SERVICE BULLETIN

TITLE: STABILIZERS - INSPECTION/REPLACEMENT OF ELEVATOR BALANCE WEIGHT ASSEMBLIES

SYNOPSIS OF CHANGE

Inspection of Elevator Balance Weight Assembly
Figure 1

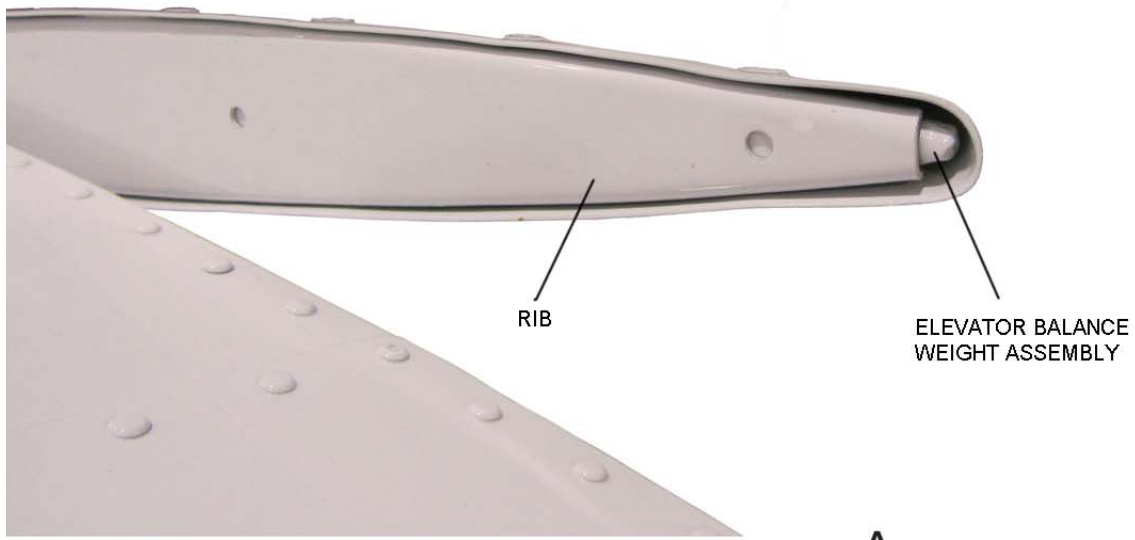
Elevator weights have been built to multiple type design revisions and may have five (5) inserts as shown in Figure 1 or four (4) inserts.

- (2) Gain access to the elevator and locate the existing elevator balance weight assembly that is installed under the elevator horn skin. Refer to Figure 1 and Figure 2.

- (3) Visually inspect to determine if the existing elevator balance weight assembly is in position and protruding from the edge of the rib. In addition, verify that the elevator balance weight assembly attachment screws on upper and lower surfaces are secure and the installation holes show no sign of discoloration. Refer to Figure 1 and Figure 2.

- (a) If the existing elevator balance weight assembly is in position, protruding from the edge of the rib, the attachment screws are secure and the installation holes show no sign of discoloration, no further action is required for this Service Bulletin. Proceed to Step (13).

- (b) If the existing elevator balance weight assembly has become dislodged, the attachment screws are not secure, or the installation holes show signs of discoloration, proceed to Step (4).

Inspection of Elevator Balance Weight Assembly
Figure 2

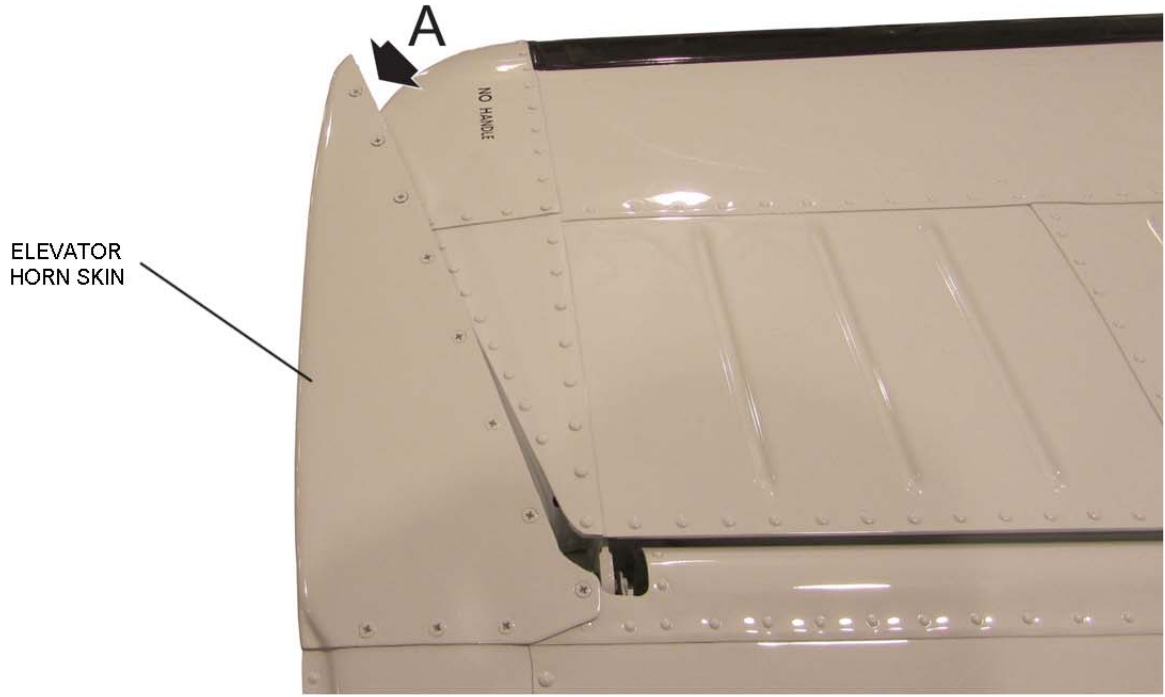
- (7) Use the screws and associated attachment hardware that were retained in Step (4) to install the applicable new elevator balance weight assembly. **Note:** New hardware may be used as necessary, as defined in Paragraph 2.C.2. The installed elevator balance weight assembly shall protrude from the rib as shown in Figure 2.
